SLPP DEFERRAL REPORT (Major Developments)

Property:	626-628 Liverpool Road STRATHFIELD SOUTH DA2021/233
Proposal:	Demolition of the existing structures and tree removal, construction of building containing five (3) industrial units and a four (4) storey hotel with a pub on the ground floor above two (2) levels of basement (comprising a retail premises and parking) and installation of associated signage.
Applicant:	Urbis Pty Ltd
Owner:	Iris Hotels Enfield Property Pty Ltd ATF Iris Hotels Enfield Property Trust
Date of lodgement:	17 September 2021
Notification period:	24 September 2021 to 16 October 2021
Submissions received:	1
Assessment officer:	G I Choice
Estimated cost of works:	\$29,794,293.10
Zoning:	B6-Enterprise Corridor - SLEP 2012
Heritage:	Proximity to I220: Weston Milling - NB Love building and administration block - old flour mill and administrative building - 22-28 Braidwood Street
Flood affected:	Yes
Is a Clause 4.6 Variation Proposed:	No

Figure 24: Submitted tree location plan (previous ground floor plan)

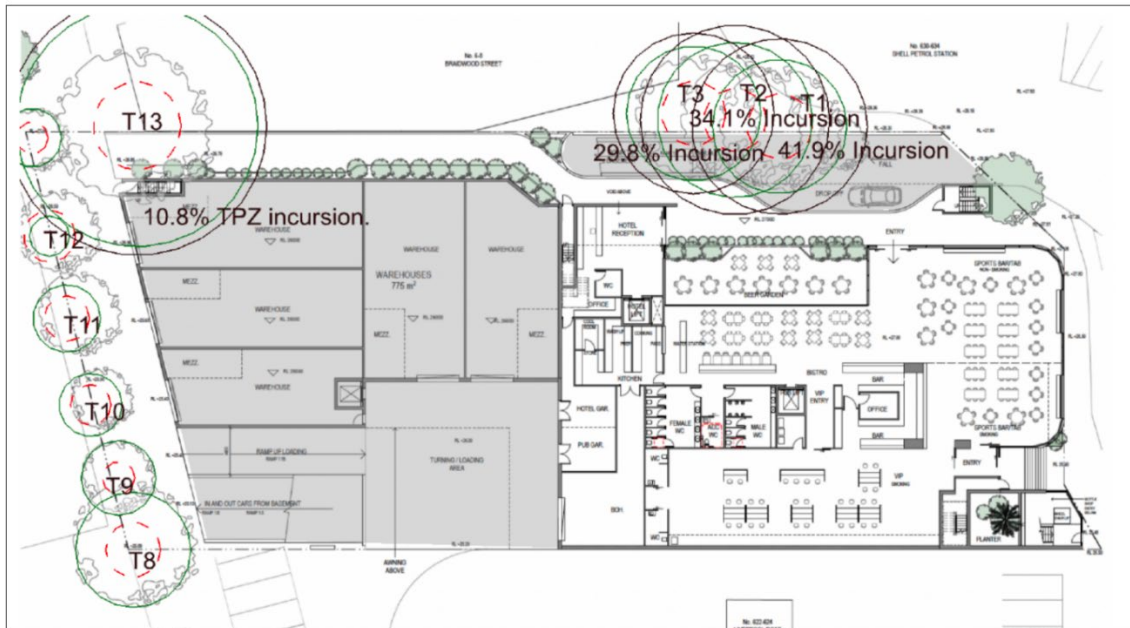
*NOTE: The revised AIA has not been updated to reflect the latest ground floor plan. Additionally, one (1) tree in the southwest corner of the site has not been identified in the AIA (see **Figure 24 & 25**).

Figure 26: Existing trees along western boundary

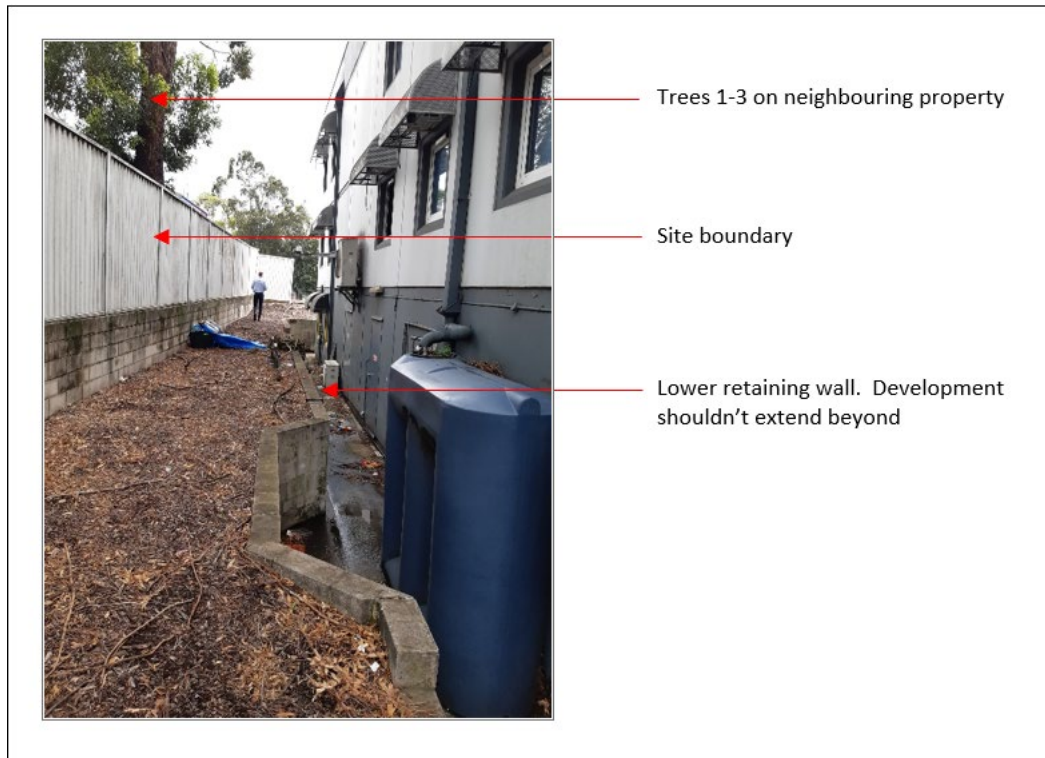
There are five (5) trees on adjoining properties located close to the subject site boundary. Three (3) of these trees T1-T3, are *Eucalyptus microcorys* located close to the subject site boundary on 630-634 Liverpool Road. As noted in AIA report, the roots of these trees have likely been constrained by the existing concrete retaining walls near this boundary. The proposed development appears not to extend beyond the existing second (lower) retaining wall (see **Figure 26**).

Confirmation is required that the proposed building and excavation does not extend beyond line of existing lower retaining wall.

Figure 26: Basement level 2 bulk storage area for hotel rooms (highlighted in red)

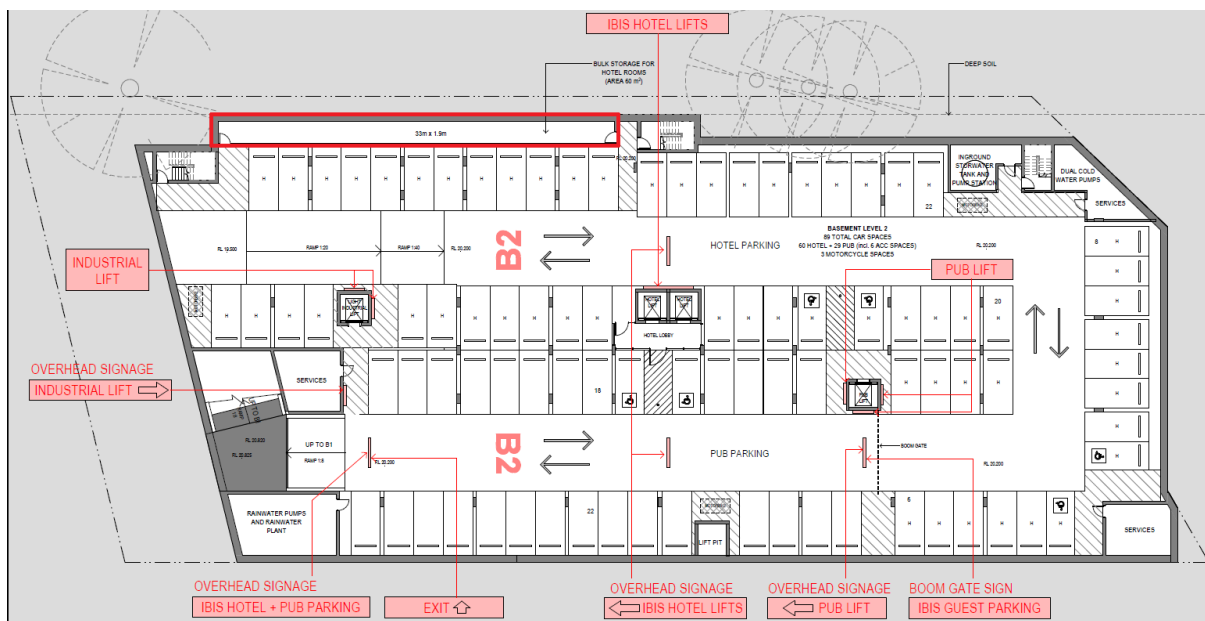
i. Basement bulk storage areas for hotel rooms

- No service lift access to Basement level 2.
- Service lift access to Basement level 1 is located on the eastern wall of the carpark and the bulk storage area for hotel rooms is located on the western wall of both basement levels.

Figure 27: Basement level 1 access issues (highlighted in red)

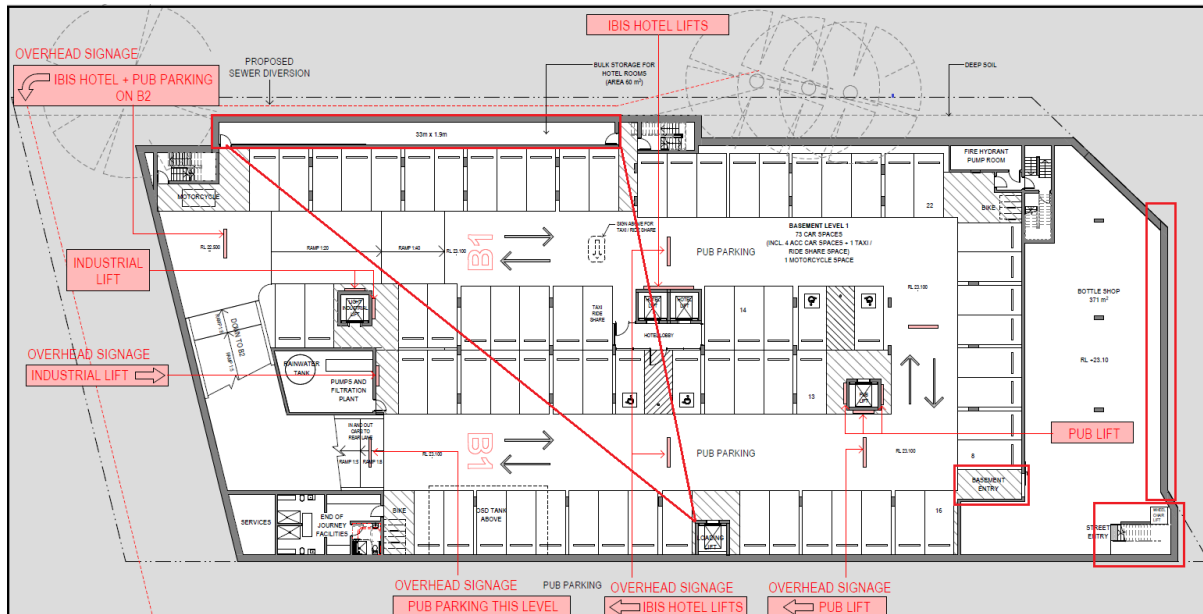
ii. Bottleshop access and design

- The proposed bottleshop will be located below the ground floor pub area.
- No windows are proposed along the northern street frontage to allow casual surveillance in and out of the bottleshop area.
- Access to and from the bottleshop is provided via to points at the same east end of the area. No alternative entrances or exits are provided.
